# **PLANNING & ZONING COMMISSION MEETING**

DSI Huxley Site Plan Phase II, Huxley Development Park

HUXLEY, IOWA DSI HUXLEY SOUTH LOT SITE PLAN REVIEW

HUXLEY, IOWA HUXLEY INDUSTRIAL PARK LOT 4 PRO COMMERCIAL SITE PLAN

HUXLEY, IOWA WESTVIEW HEIGHTS PLAT 3 FINAL PLAT

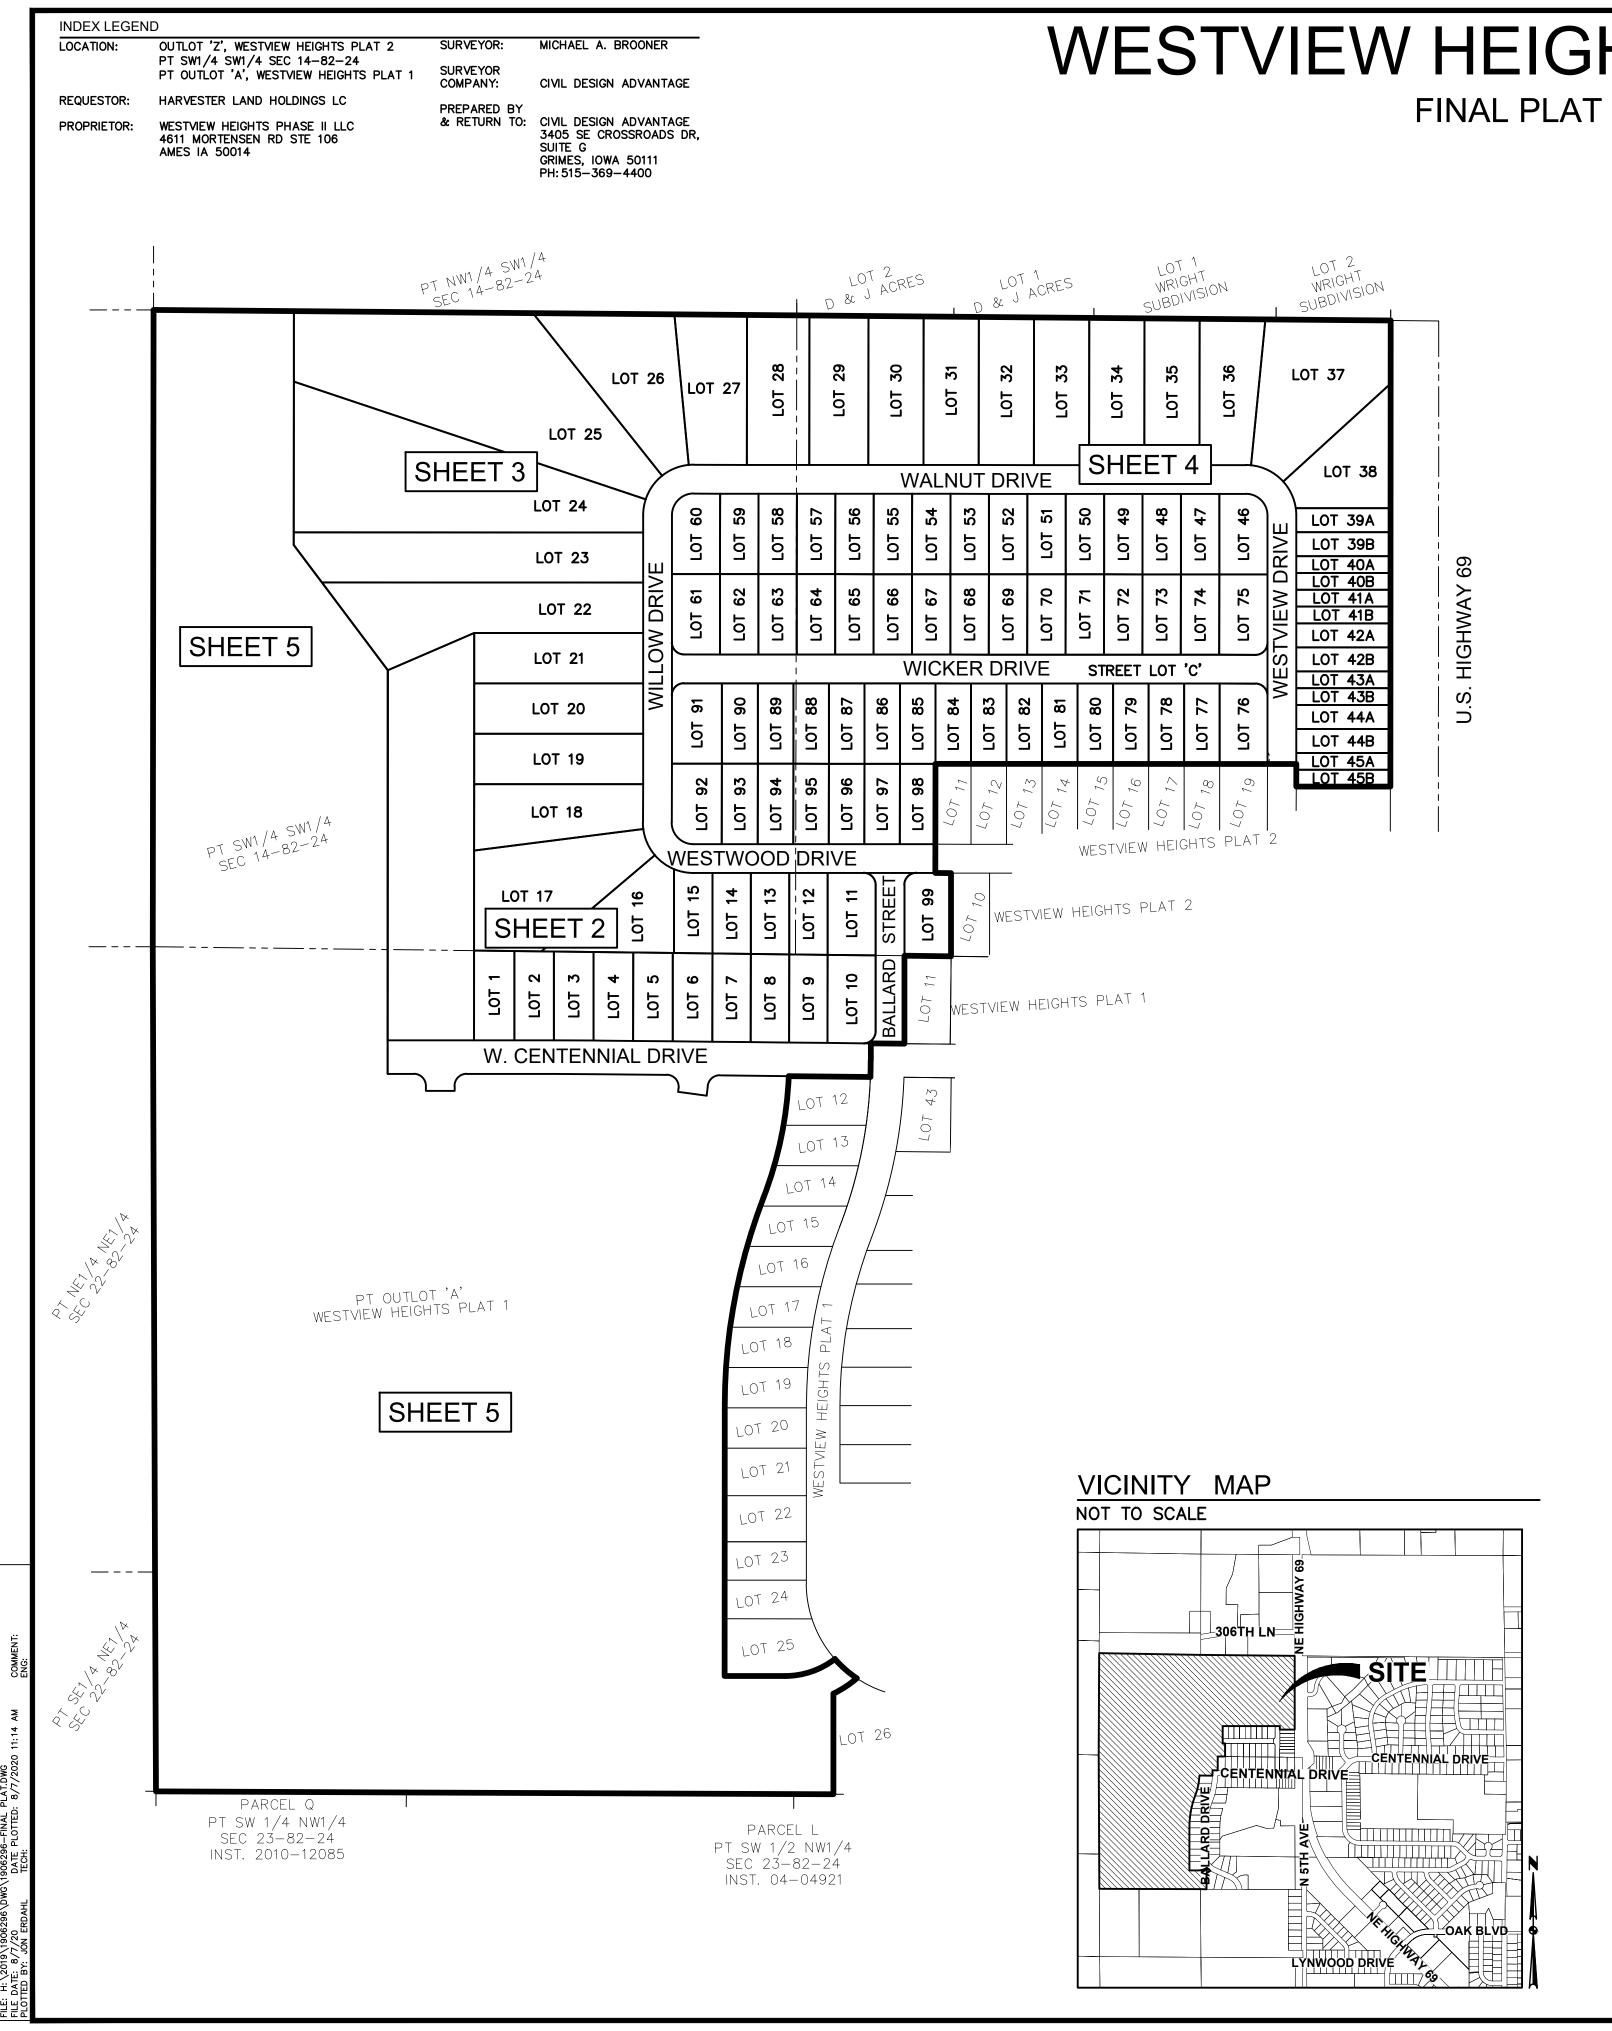
- 1. Backyard drainage elevations and slopes need to be provided on a separate sheet sealed by a licensed engineer.
- 2. The easement between Lots 17 and 18 needs to also be labeled as a recreational trail easement and the description added to the legal easement descriptions.
- 3. Label lot street address numbers.
